MICRO-DISK SYSTEM ERRATTA AND ADDITIONAL INFORMATION

February 15, 1977

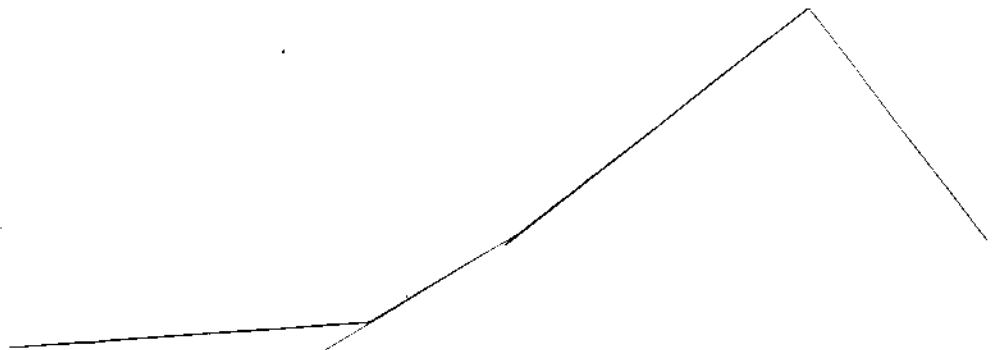
- ✓ Cut trace connecting 9E pin 1 to 9E pin 15.
 - ✓ Add jumper wire connecting 9E pin 1 to 9F pin 7.
6. Disk drives now being delivered must be programmed somewhat differently than what is described in the DISK DRIVE CONFIGURATION section of the MICRO DISK SYSTEM document. The MUX trace which must be cut for multiple drive operation is now located on the header at 1F and is the strap labeled MX. The five straps that were labeled T1, T2, T3, T4, and T5 have been removed. The termination resistors are located at 1E. This resistor package should be removed in all drives except the one at the end of the ribbon cable. Be sure that the HS strap at 1F remains connected and the HM strap remains disconnected.
